SITE PLAN MODIFICATION OF 505 WEST CENTRAL STREET, LOT 3 (515 WEST CENTRAL STREET) FRANKLIN MASSACHUSETTS

**SITE PLAN MODIFICATION
505 WEST CENTRAL STREET
LOT 3
(515 WEST CENTRAL STREET)
FRANKLIN
MASSACHUSETTS**

**Re: 515 West Central Street
Site Plan Modification Peer Review Update**

RE: Site Plan Modification – 515 West Central St Daycare

EROSION CONTROL
PLAN

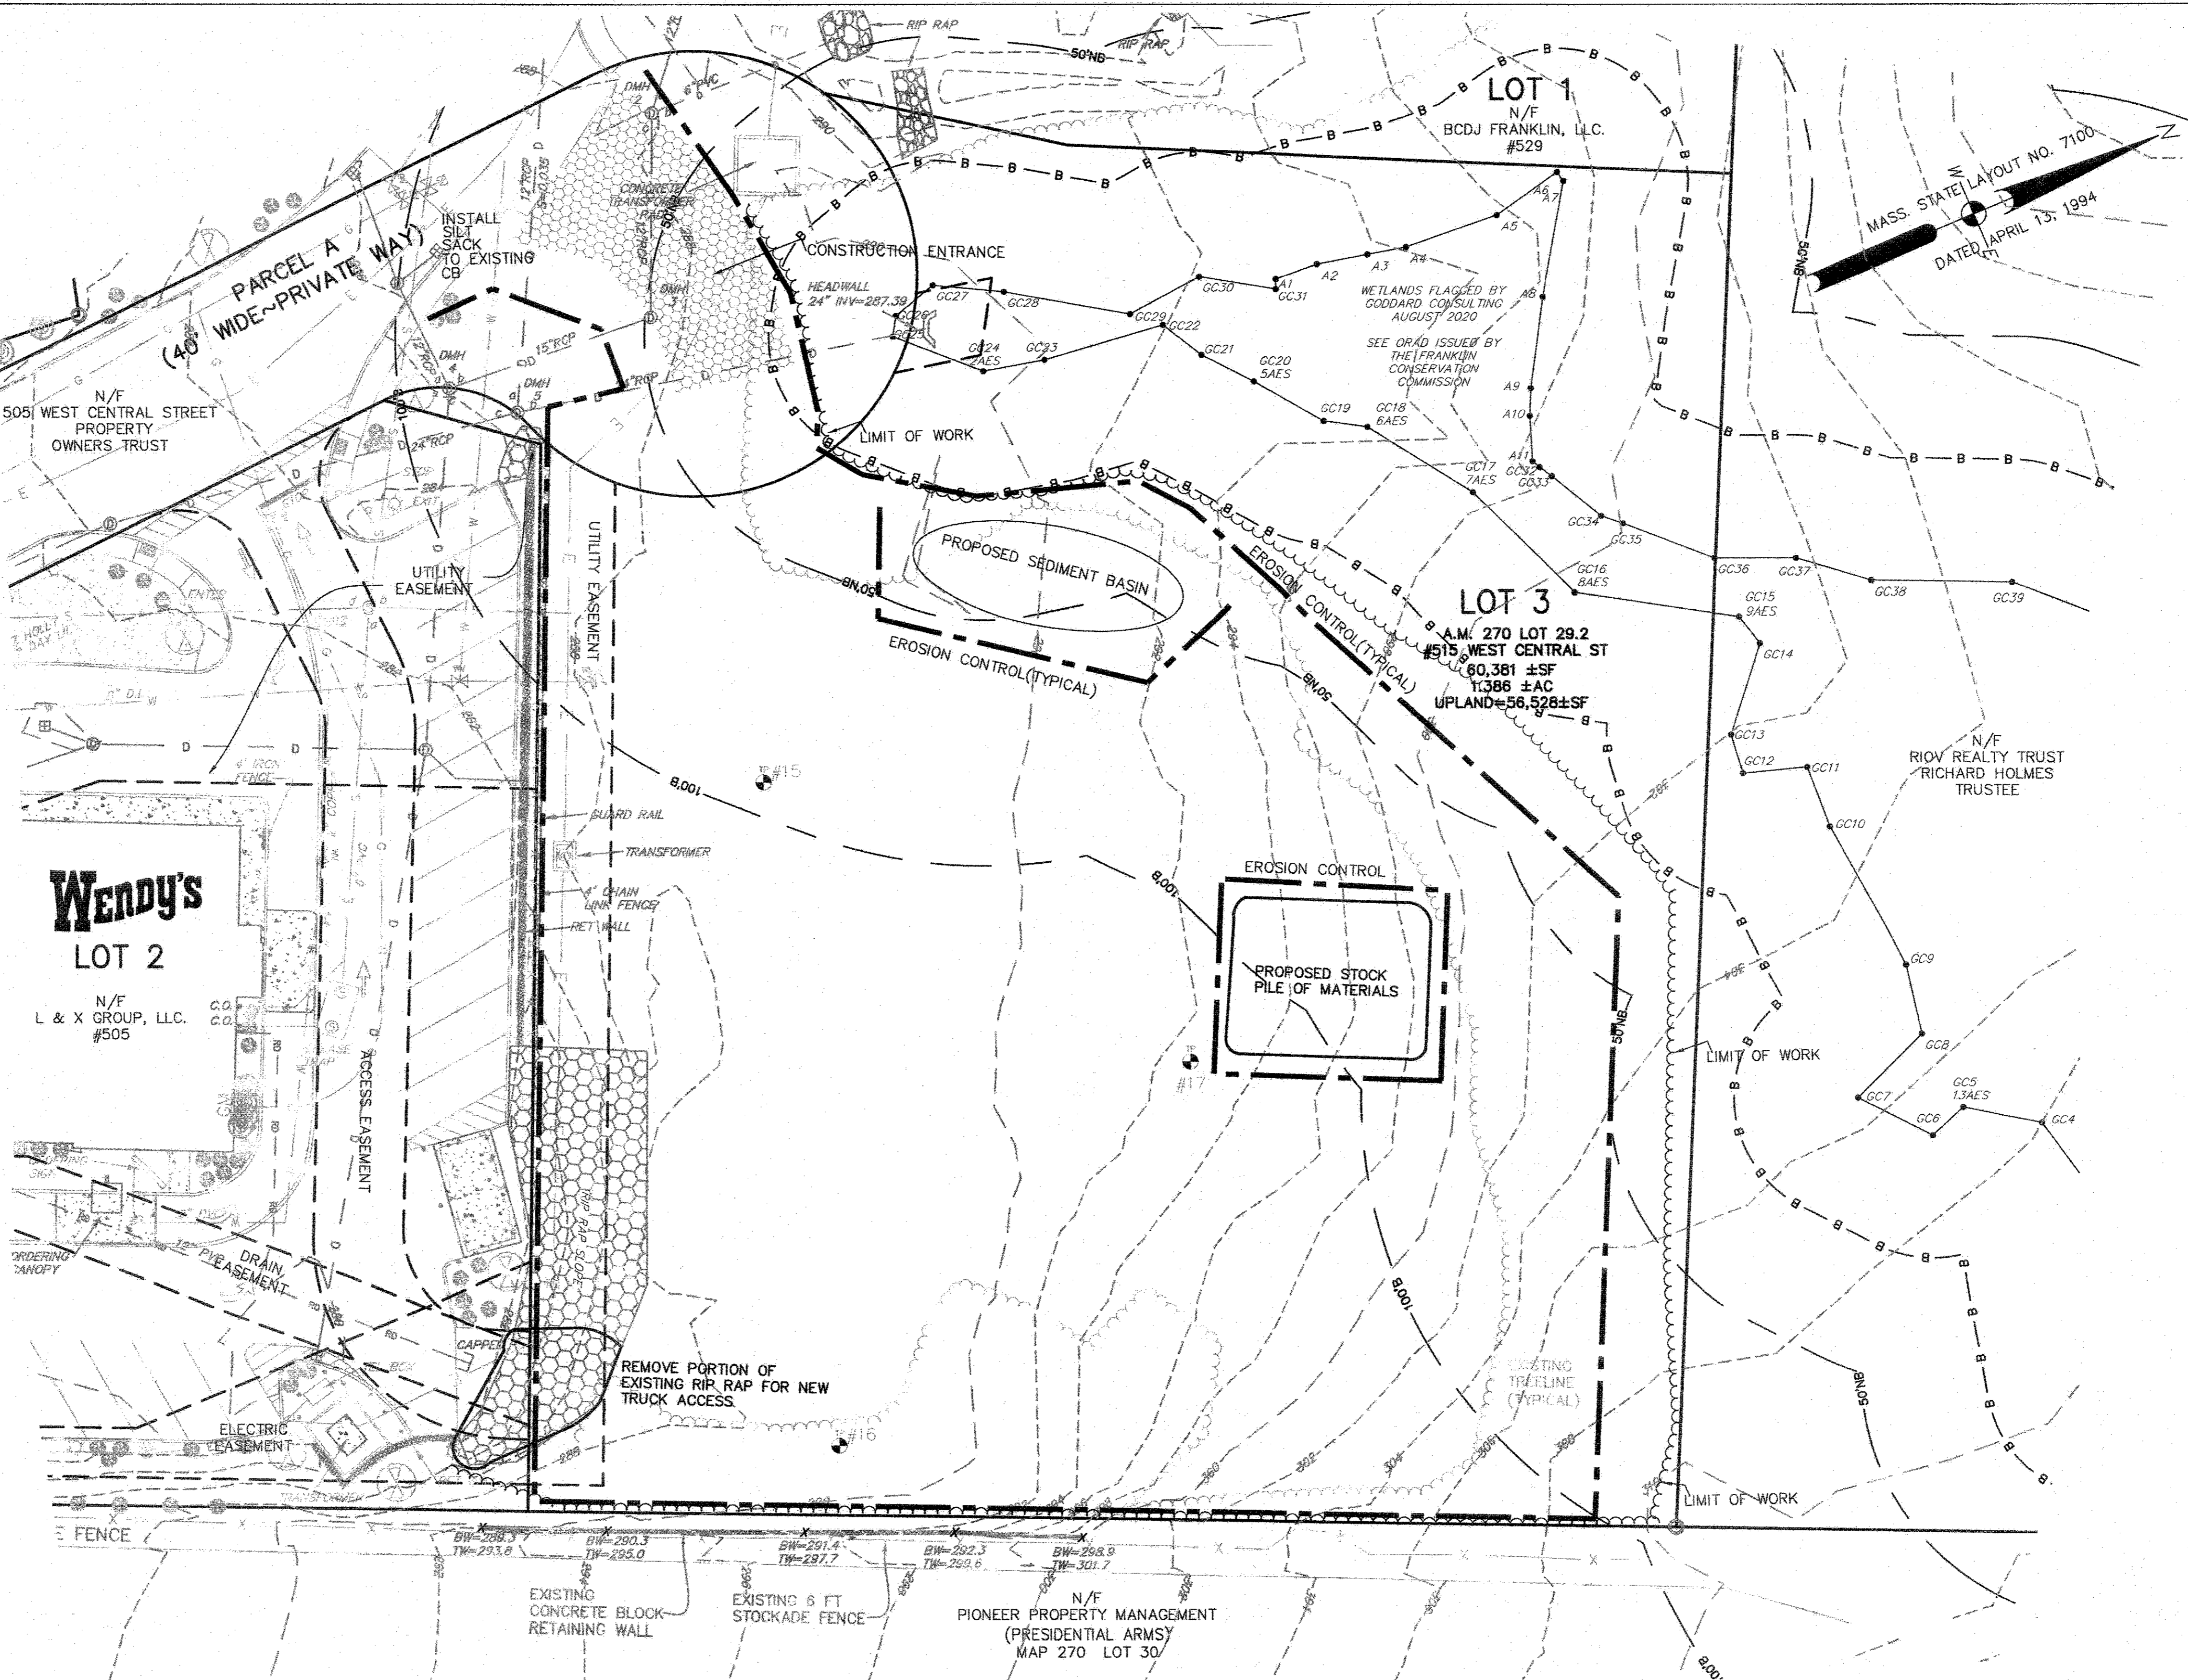
SW7. Revise erosion control barrier to be located on the downgradient side of the proposed stockpile area.

SW7. Revise erosion control barrier to be located on the downgradient side of the proposed stockpile area. *GHI: Additional erosion control barrier has been proposed on the down gradient side of the stockpile as requested. See sheet 3 of the revised site plan set. BETA2: Erosion control barrier location revised – issue resolved.*

GH: Additional erosion control barrier has been proposed on the down gradient side of the stockpile as requested. see sheet 3 of the revised site plan set.

SW6. Indicate location of proposed silt sacks, including within the Parcel A right-of-way. *GHI: Notes have been added to the erosion control plan to indicate the location of silt sacks. See sheet 3 of the revised site plan set. BETA2: Notes provided – issue resolved.*

GH: Notes have been added to the erosion control plan to indicate the location of silt sacks. See sheet 3 of the revised site plan set.

SITE PLAN

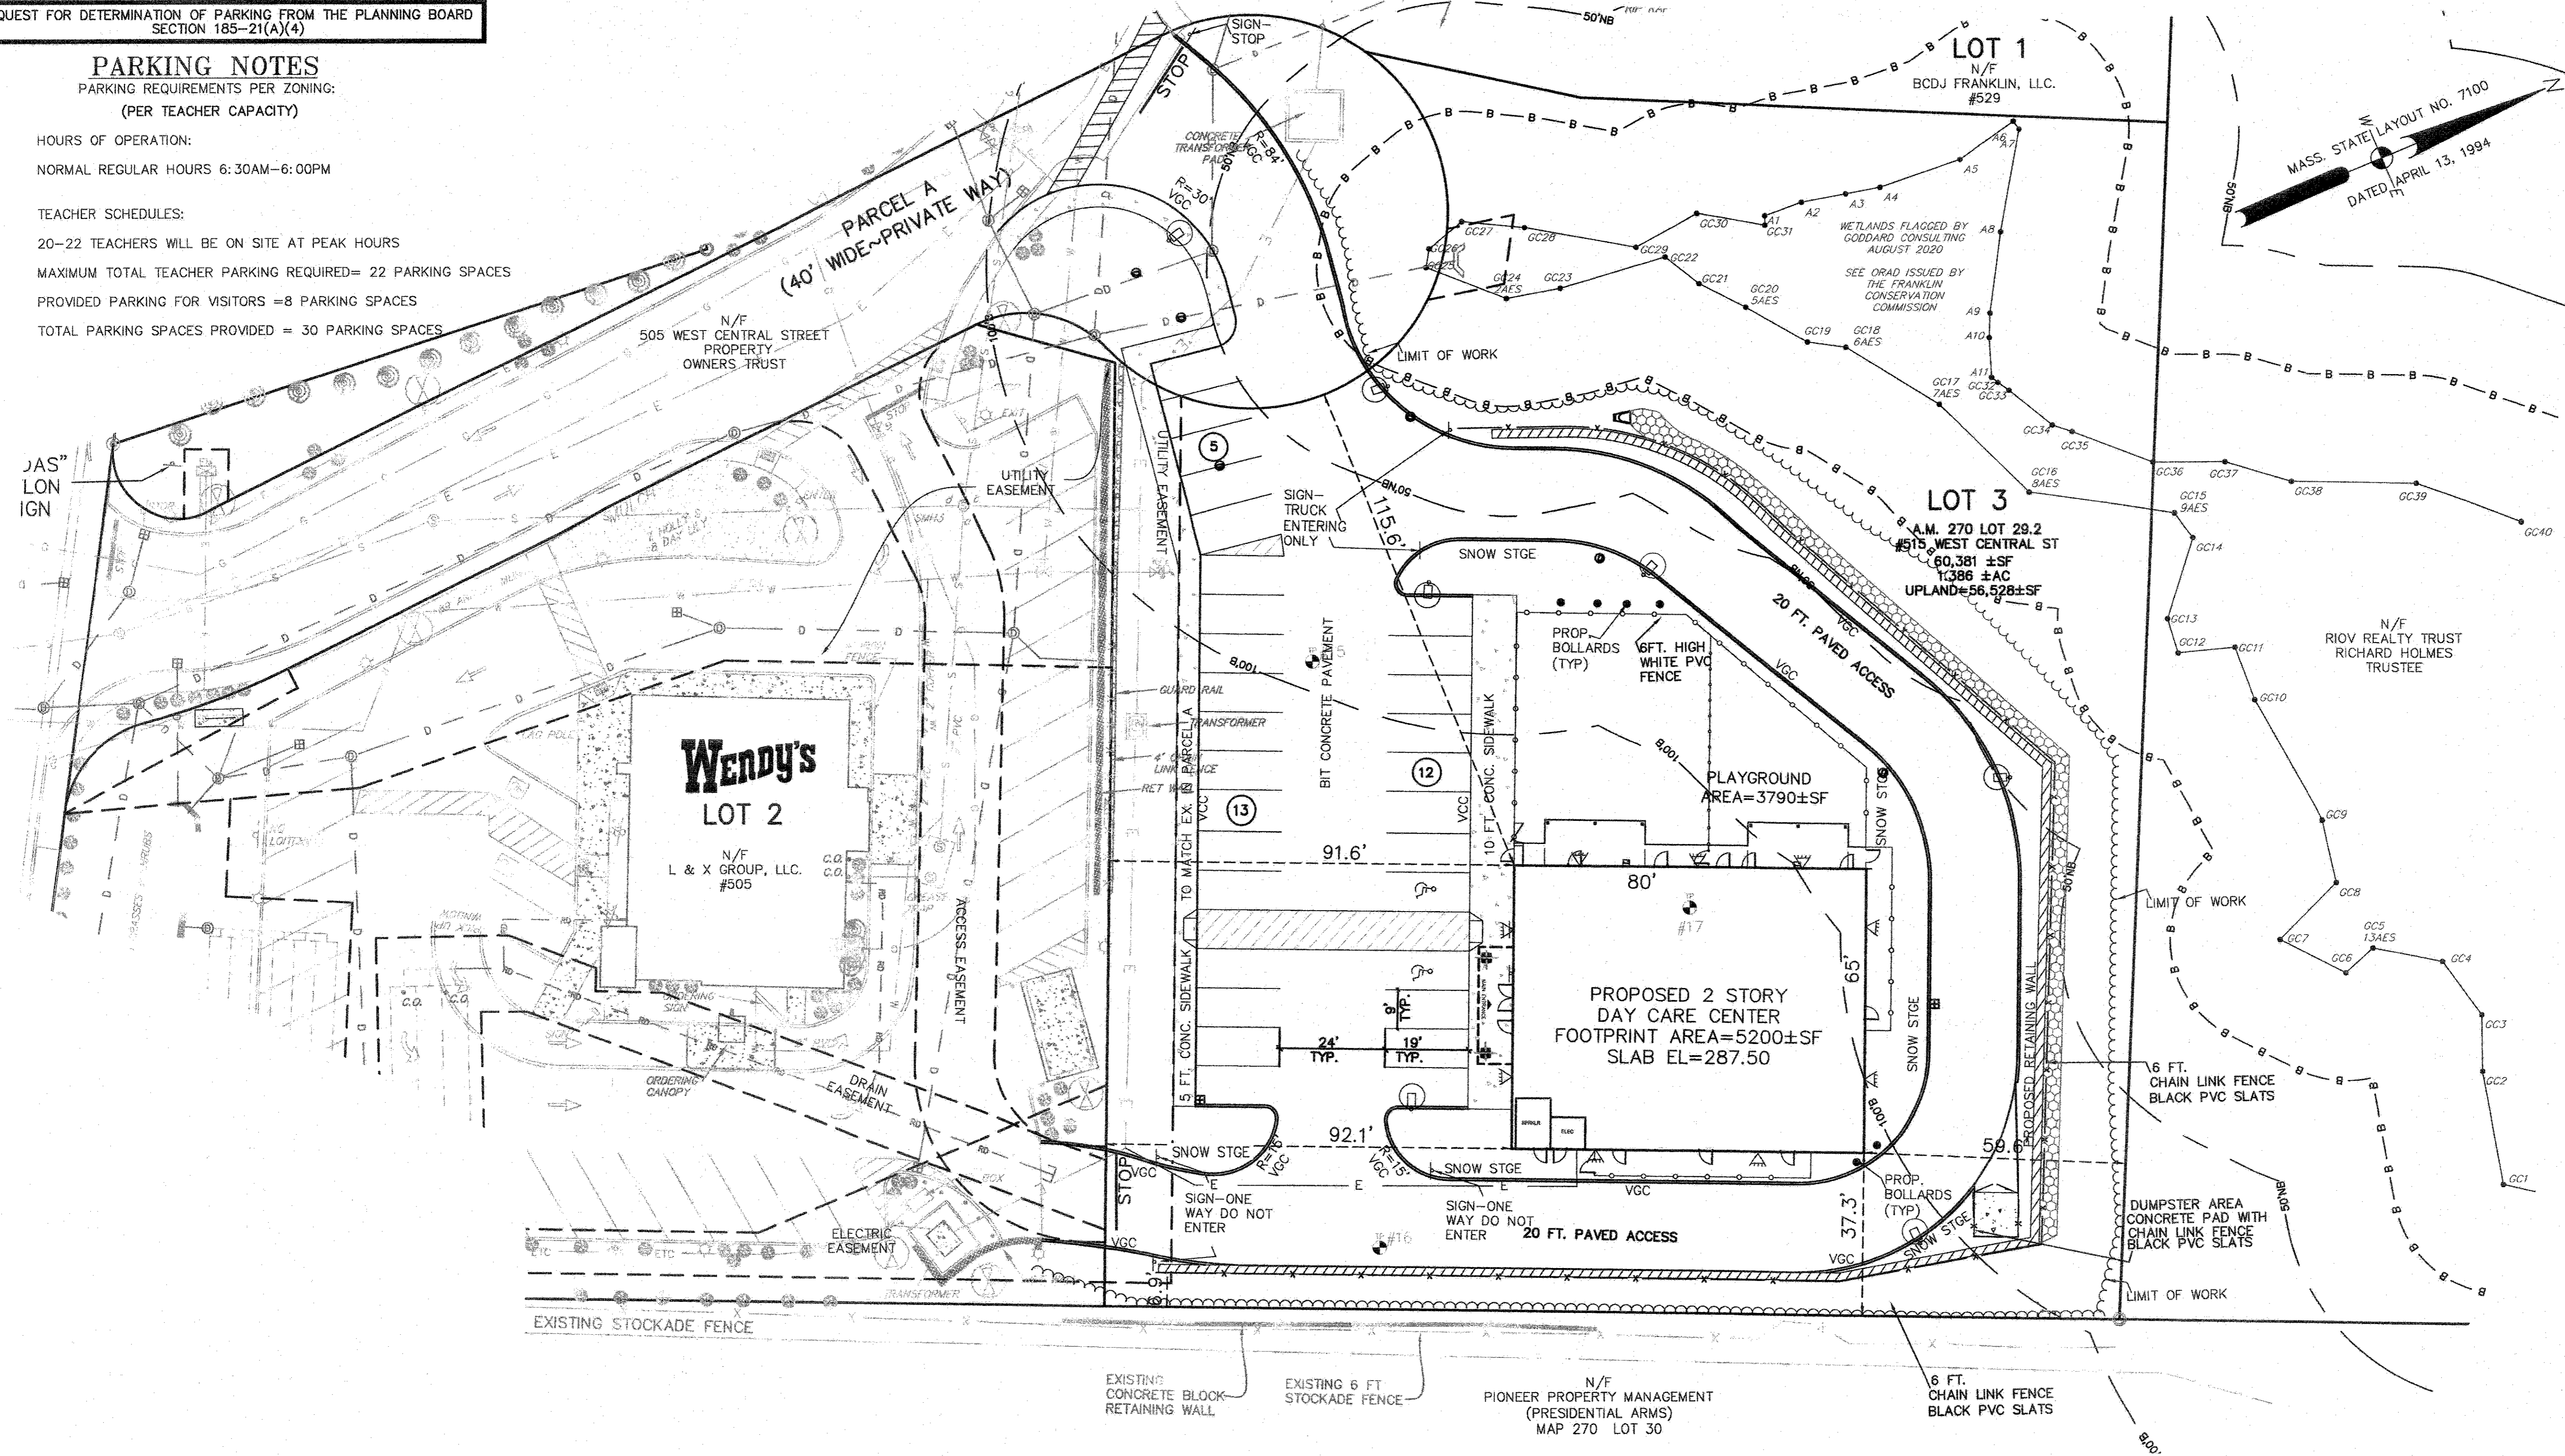
- C1. *Consider providing vertical curb at the driveway connection to Parcel A to match the existing curbing. If sloped curbing is to remain, indicate the location where the sloped granite curbing transitions to vertical concrete curbing and provide location and detail for sloped-face to vertical-face transition curb.*

GH: Vertical curbing at driveway connection to Parcel A has been provided. Please see sheet 4 of the revised site plan set.
